Formula SAE-A Rules Inquiries

Questions and Answers

Primary Structure Envelope

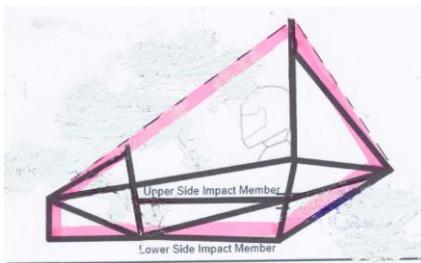
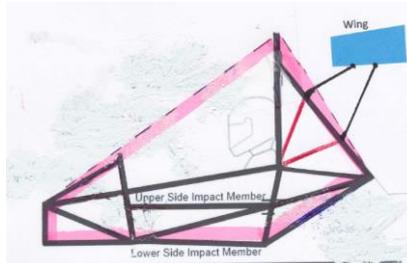
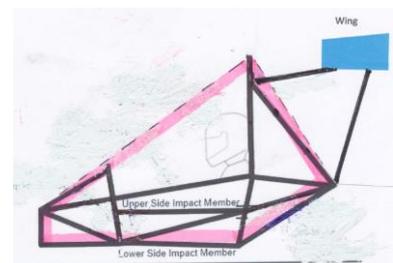
Question (part1): *I was planning to mount a bracket on the backside of the main roll hoop bracing that will then attach to the upper side of the rear wing as a mount (swan neck mount). However, I am confused as to what "additional bracing" must be added to the roll hoops to prevent bending loads in the braces in any rollover attitude?*

Question (part 2): *The rear wing was designed to have a bracket that is attached to the Main roll hoop bracing and top side of the rear wing. However, I am unsure what is classified as "additional bracing" and if there is any particular requirements that need to be met; such as specific areas where there needs to be additional mounting or specific bracing types.*

Answer: To avoid bending loads from anything mounted to the rear braces (such as a wing) from inputting a bending load to them, an additional tube would usually be required at the point where the wing mount

attaches to the brace, creating a node which would then attach at the other end to a node on the Primary Structure, thereby creating triangulation and avoiding bending loads.

The three attached rough sketches should assist understanding the application of the rule, whereby the first shows a typical PS Envelope; the second shows a wing outside the PSE, mounted to the MRH Brace in a way that would require triangulation with additional tubes; the third shows an approach to mounting which does not load the Brace in bending and would avoid the need for additional tubes.

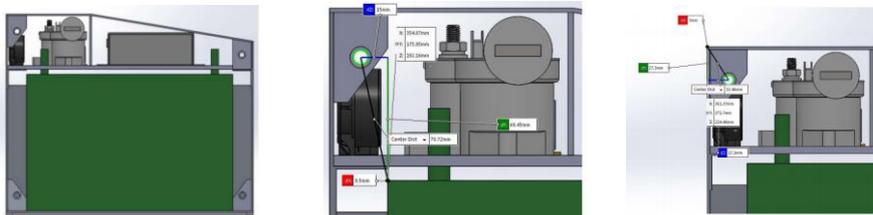
Our proposed cell arrangement is 90s8p. This is made of six segments of 15s8p connected in series. Within each segment, each series step is joined by a bus bar, such that the parallel strings are not separated.

In this arrangement, the parallel cells behave as one cell, and are subject to the overall pack over current protection.

Our interpretation is that the rule applies to series-parallel configurations where the bus bar is not present. Given the above details, does the fuse placement in the circuit diagram below satisfy the requirements of the rule?

Answer: In respect to your question regarding the compliance of your proposed fusing design with EV,8.1.5, your proposed fusing arrangement is acceptable.
